YUCCA MOUNTAIN PROJECT
CONTROLLED SCIENTIFIC NOTEBOOK

Activity Number/Task: RESEARCH SUPPORTING ENVIRONMENTAL
CHEMISTRY EXPERIMENTS

TECHNICAL REVIEW FOR SN-LLNL-SCI-478-V3

Technical Review Comments

Figure 1. Schematic of test setup

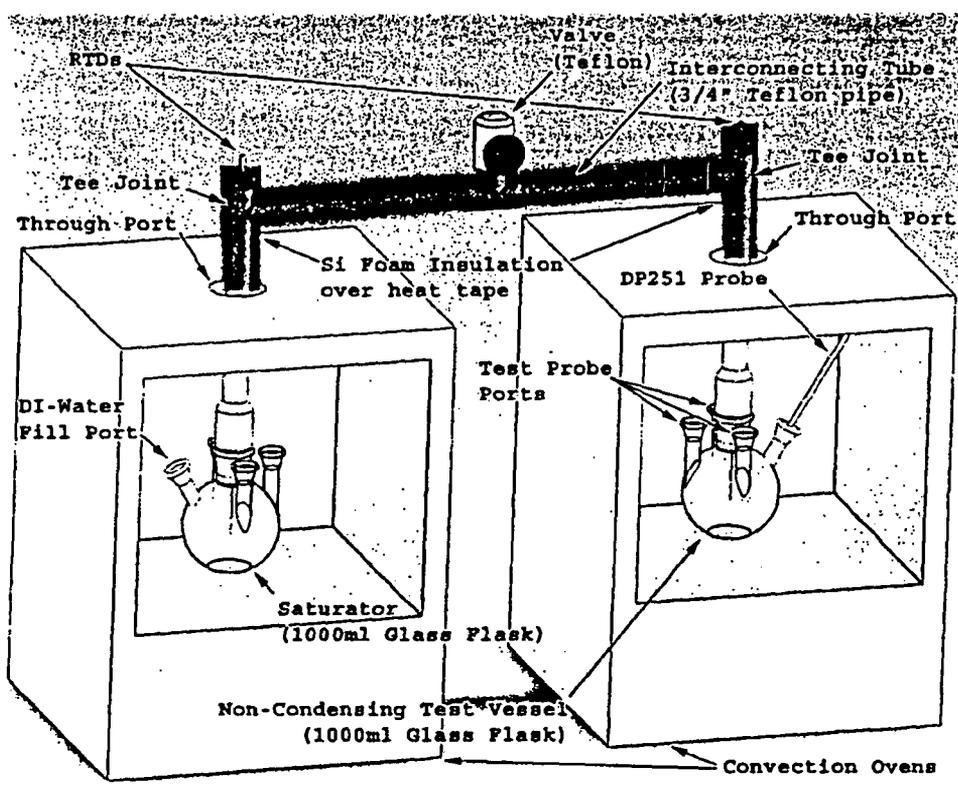
p. 3-5: Note what an RTD is.

Noted on page 4

Figure 2. Plotted data and curve fit from CRC.

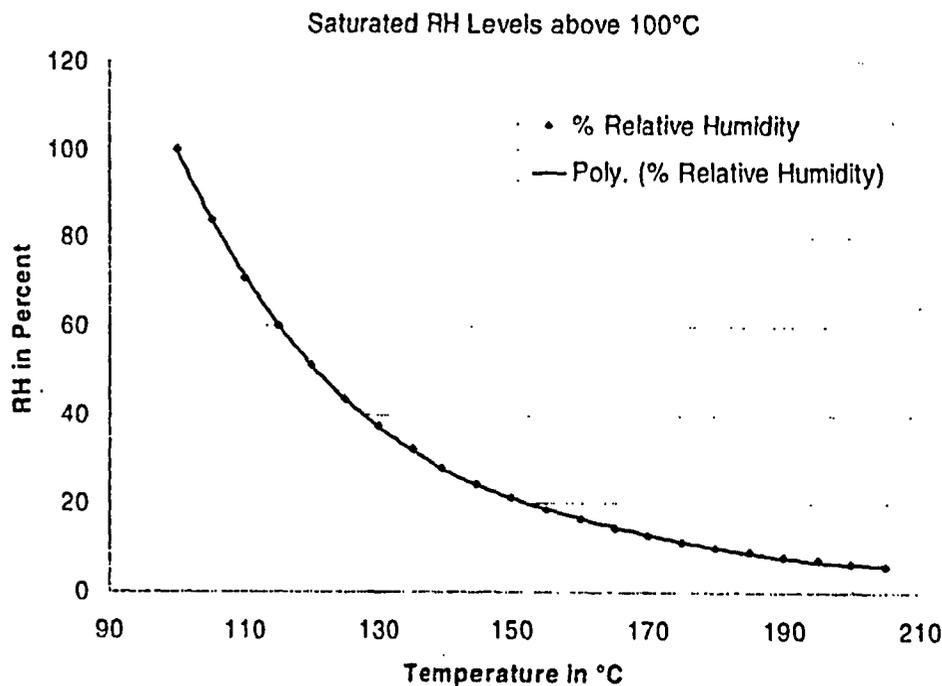
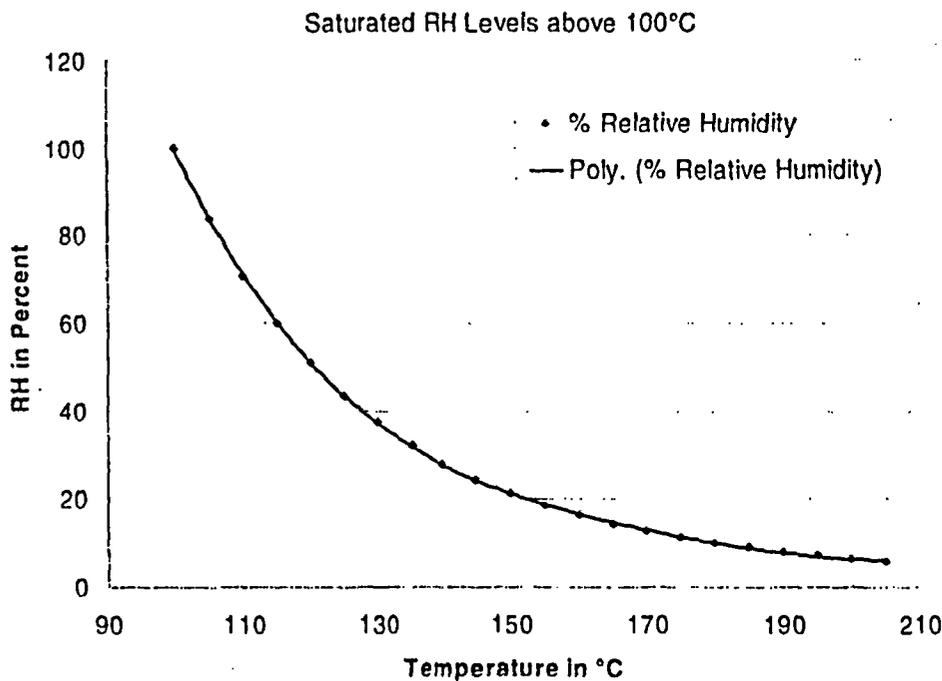
p. 7. Table 2: "Data from CRC". The cited source needs to be more definitive. I would suggest Weast and Astle 1981 [DIRS: 100833], p. D-168 to D-169 (Note: Greg Gdowski has a copy of this version of the CRC Handbook). If this is used, the units are "torr.", not "mm" (actually mm Hg), though these are numerically equivalent. The RH% numbers are calculated, not taken from any CRC source I am familiar with. How they were calculated needs to be documented, including identifying any software used and any resulting spreadsheet, including DTN, that may be involved. For 110°C, the RH% is given as 70.72. I calculated 70.73 (rounded to two decimal places).

p. 7. Table 3: The equation given (to nine-th order) is not what was actually used. It is clear from a recalculation I did that the fit was only to fifth-order, matching the coefficient labels given in the table. Using Excel's "regression tool" I got slightly different results for the coefficients themselves, possibly because the RH% values I used were not truncated to two decimal points as in Table 2, or possibly because of the 70.72 value instead of 70.73 noted above. There is a documentation issue here. How were these coefficients obtained, and with what software (obviously something was used).

As noted by reviewer, fit is to the 5th polynomial. The 0th order heading is general format generated by Kaleidagraph software used to fit the data. Difference noted in second significant figure at 110 C for calculated RH is likely a rounding artifact between fitting procedures in Excel used by the reviewer and Kaleidagraph used by the investigator. This difference is inconsequential because probes tend to only one significant figure. See entry on page 7 and 27.

baffle plate 2-8-06

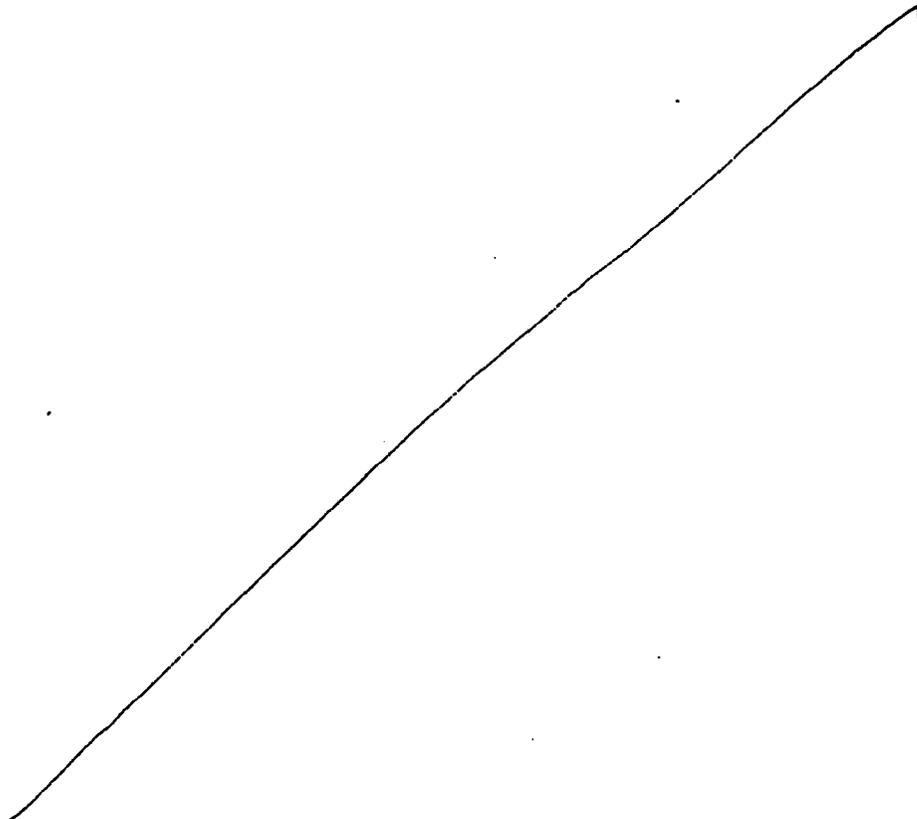
p. 12: Illegible parts: "Added teflon b?????" (line 1 following the date) and "to try and ever ????" (on line 2).

p. 12: Illegible parts: "Added teflon b?????" (line 1 following the date) and "to try and ever ????" (on line 2).
Corrected
